In response to the outstanding Official Final Action dated October 18, 2002 and due for response January 18, 2003, Applicant encloses a Request for a three month extension of time with the fee for a small entity of \$465.00 U.S. funds making this response due April 18, 2003. If there is any deficiency or surplusage of the fees enclosed for the Extension of Time (fee), please obtain any such deficiency or credit the surplusage to Deposit Account 08-3255 and advise Applicants' Agent.

IN THE DRAWINGS

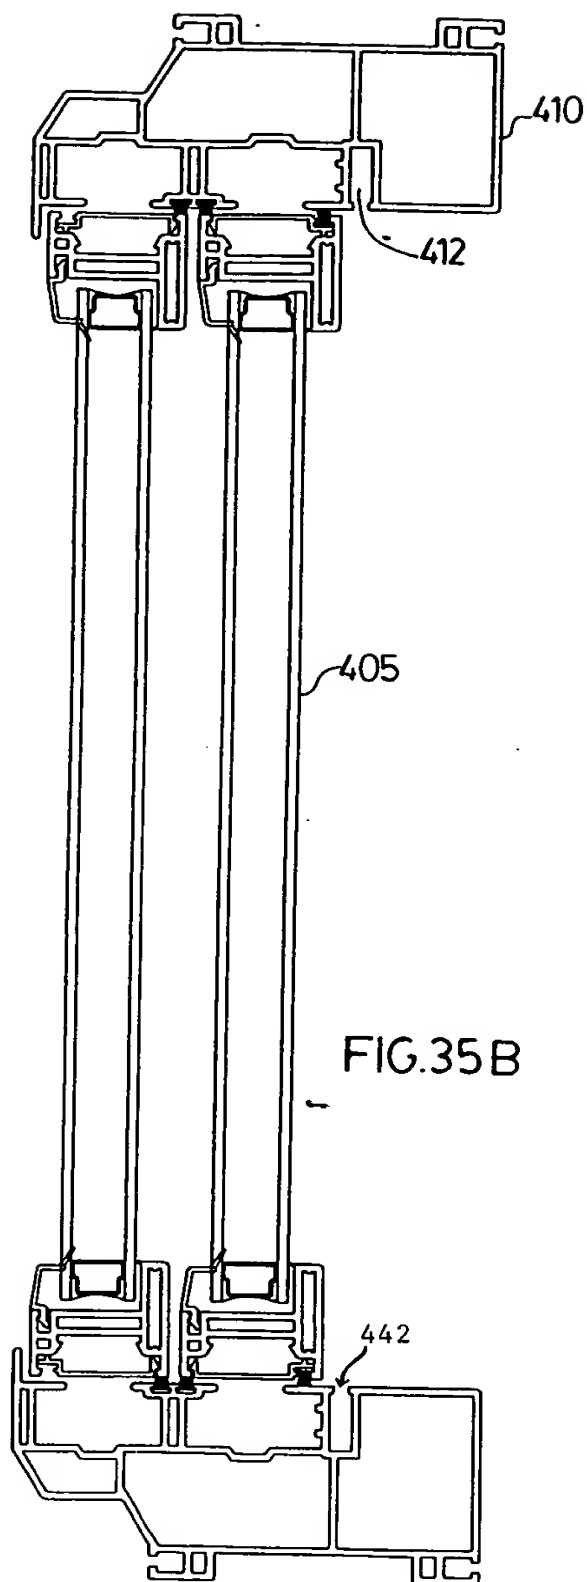
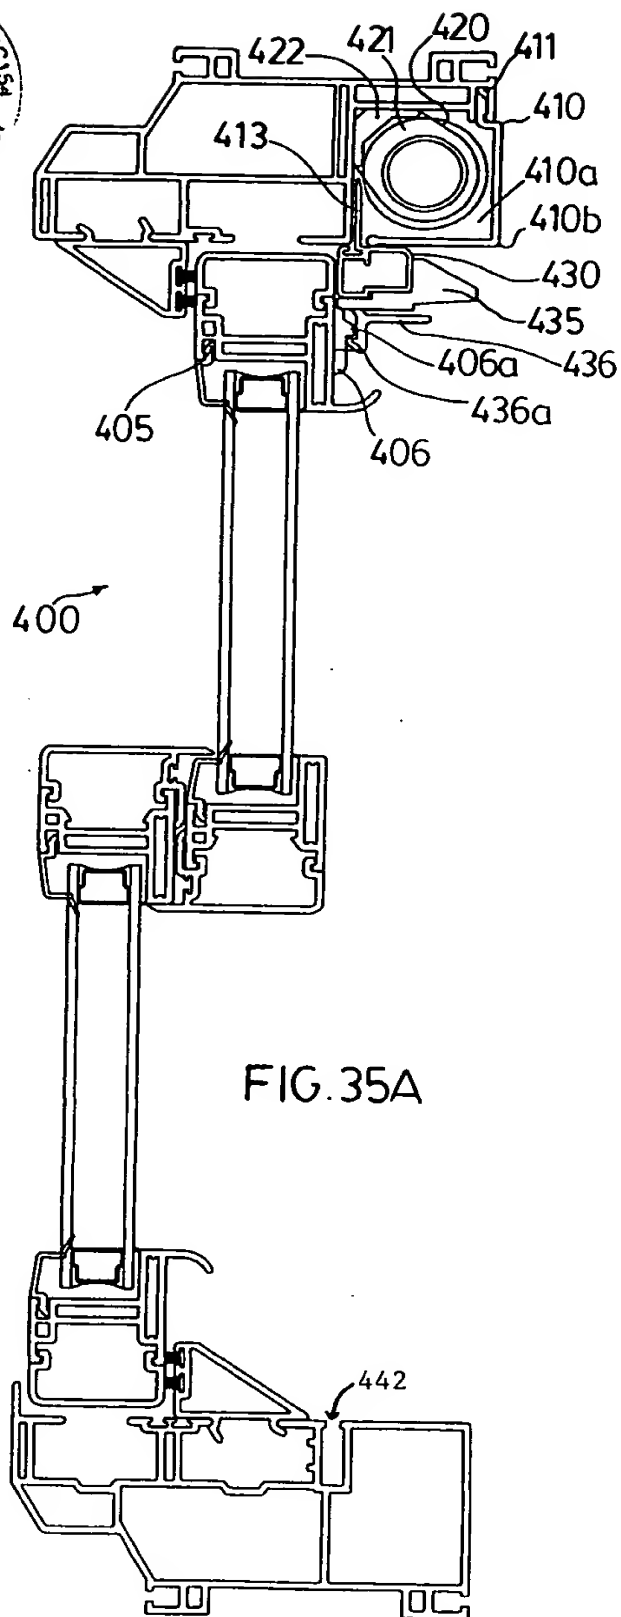
The Examiner has stated that the drawings do not illustrate the features of claims 2 and 10. Applicant respectfully disagrees. Clearly elements 441 and 442 of Figures 35A, 35B, 36 and 38 by way of example (attached) clearly indicate that the guides 412 are providing with the sill and header portions. These may be considered to be guides or grooves as defined in claim 2 and 10. The Examiner is specifically referred to page 45 of the disclosure line 6 onward wherein it states,

"Because of the design of the screen including the telescoping guides as best seen in Figure 36, the screen is guided through channel 412 as best seen in Figure 35B between fully closed and fully opened positions. The glide assembly therefore will accommodate and receive the upper edges and the bottom edges of the generally T-shaped screen portion as best seen and described in relation to Figure 20. An upper glide 441 therefore and a lower glide 442 is provided to ride within the respective channel portions 412 of the jamb framing sections."
